HISTORIC AND DESIGN REVIEW COMMISSION

May 01, 2024

HDRC CASE NO: 2024-157
ADDRESS: 146 NAVARRO ST
LEGAL DESCRIPTION: NCB 125 BLK LOT 13 (CPS ENERGY NAVARRO)
ZONING: D, H, RIO-3
CITY COUNCIL DIST.: 1
DISTRICT: La Villita Historic District
APPLICANT: Jessica Milligan/GarzaEMC
OWNER: BH 146 NAVARRO STREET LLC
TYPE OF WORK: Construction of a surface parking lot
APPLICATION RECEIVED: April 15, 2024
60-DAY REVIEW: June 14, 2024
CASE MANAGER: Edward Hall

Historic and Design Review Commission
Design Review Committee Report

146 Navarro - Schematic Landscape

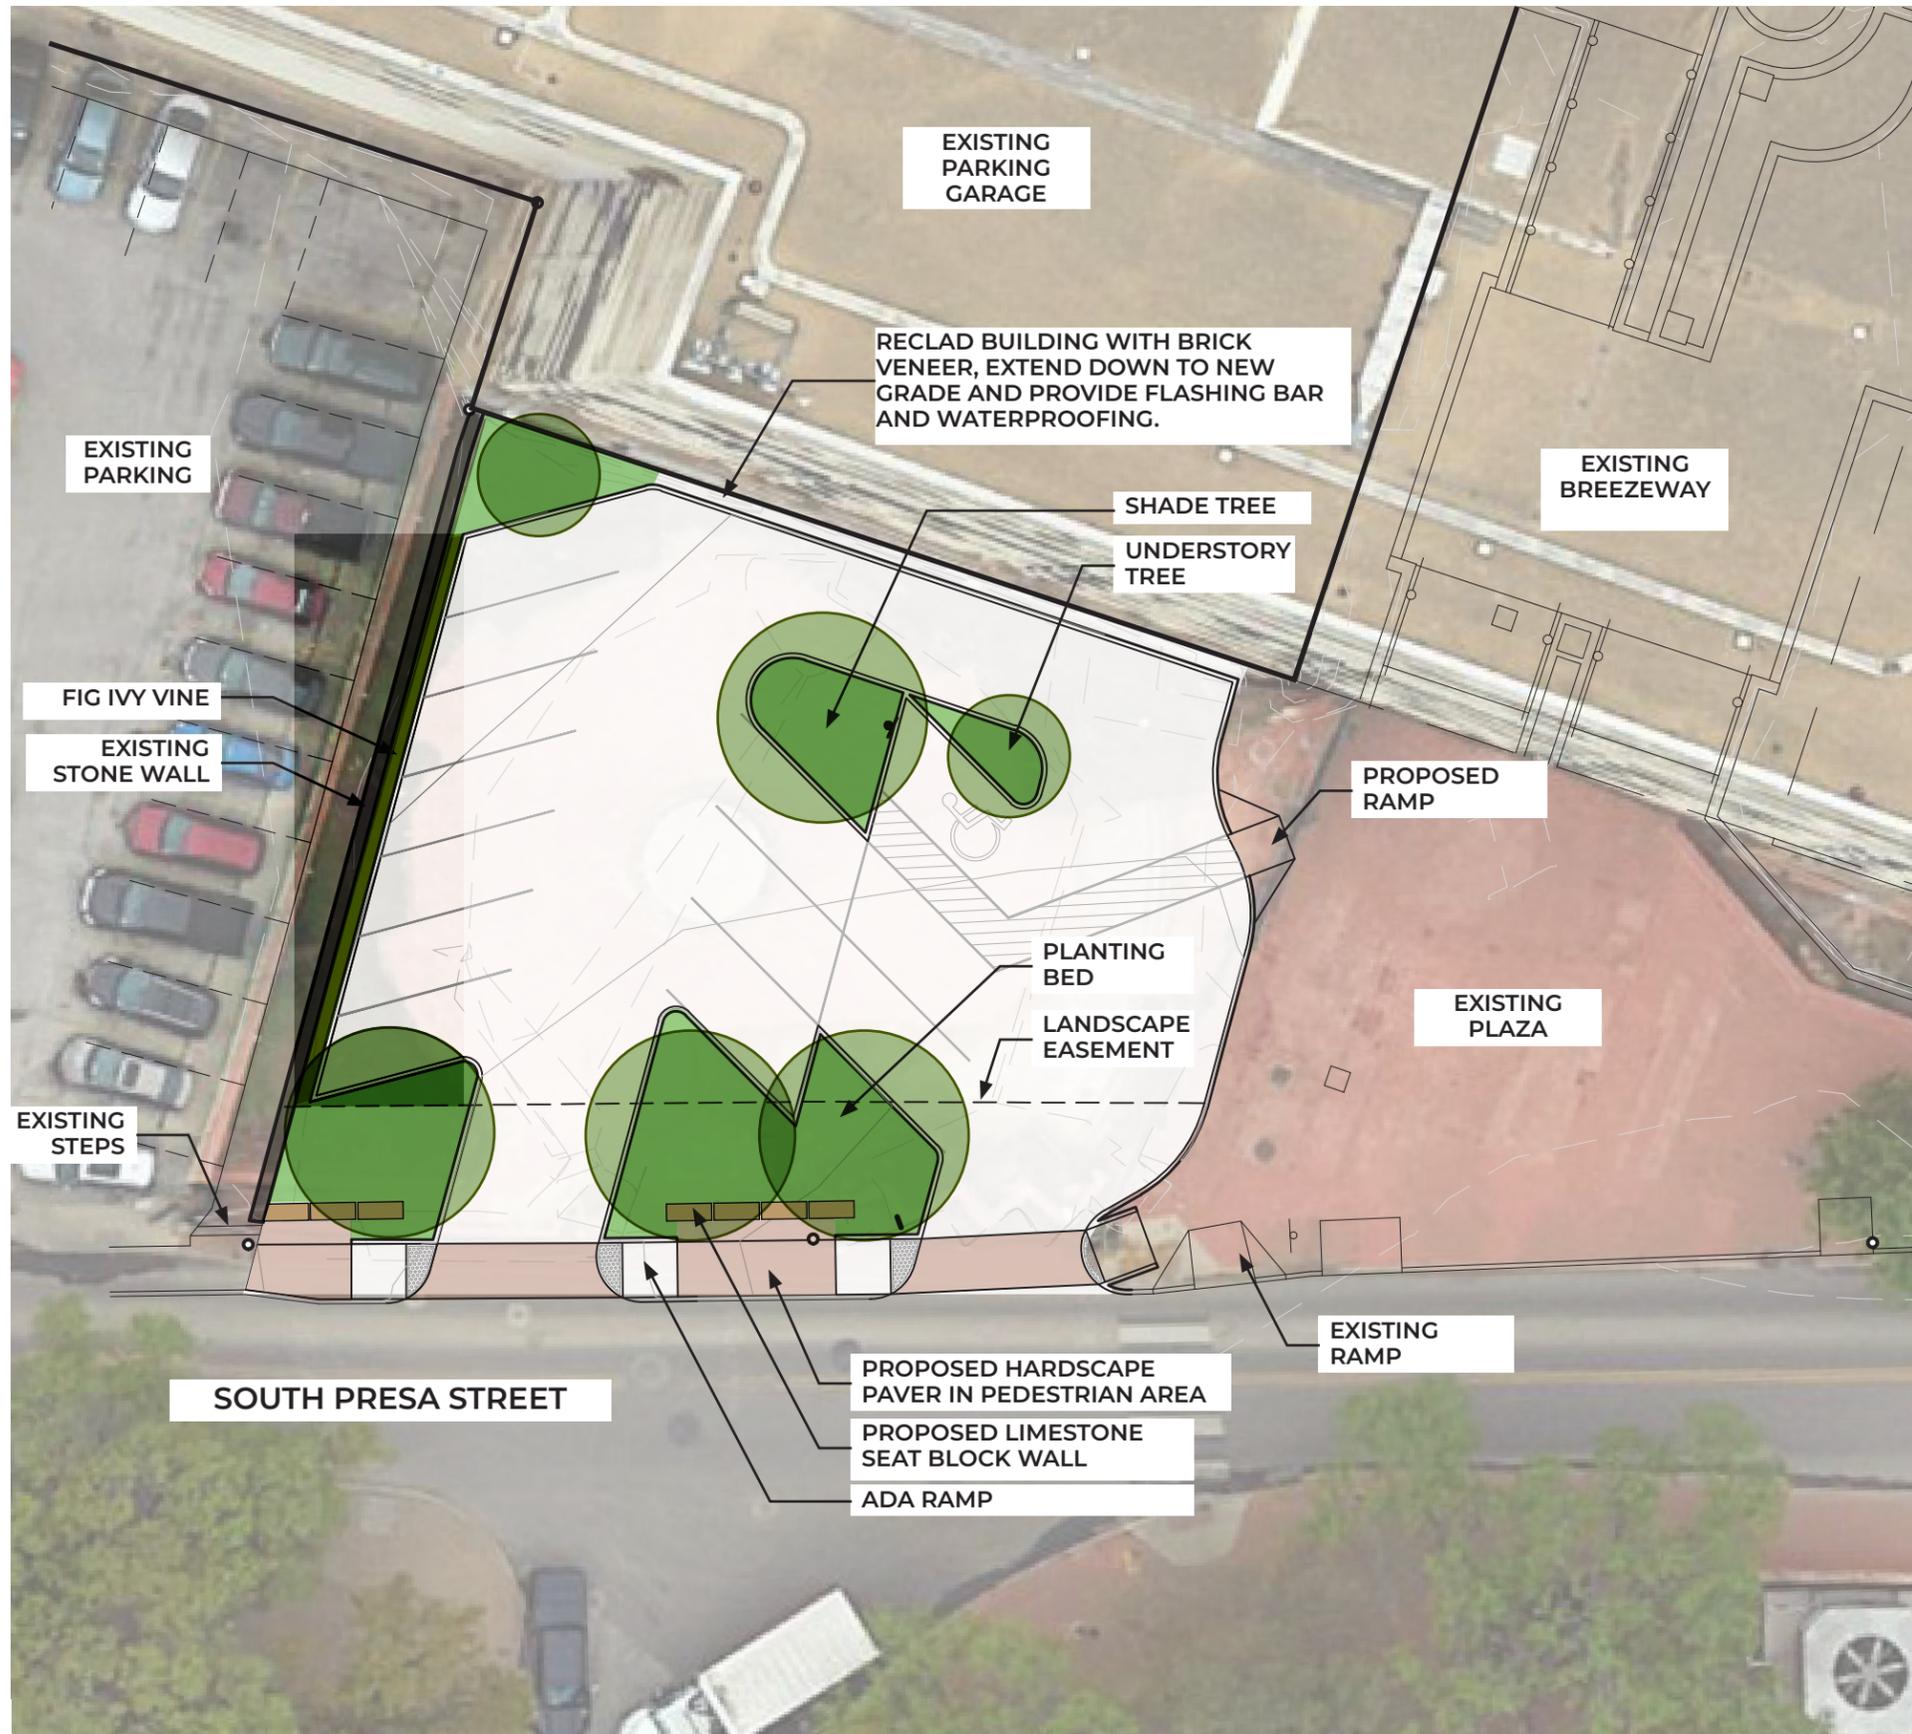
JF: Questions regarding note to reclad building in brick veneer. BT: Brick will be installed where existing plaza elements are removed and exposing area.

JF: Will any additional landscaping be added to other areas (not within landscaped area). Consider linking new landscaping with existing landscaping to the north.

MP: Will pedestrian seating be proposed? BT: Yes, seating will be provided under the shade trees for pedestrians.

JF: Plan to show the existing plaza to the north with existing trees.
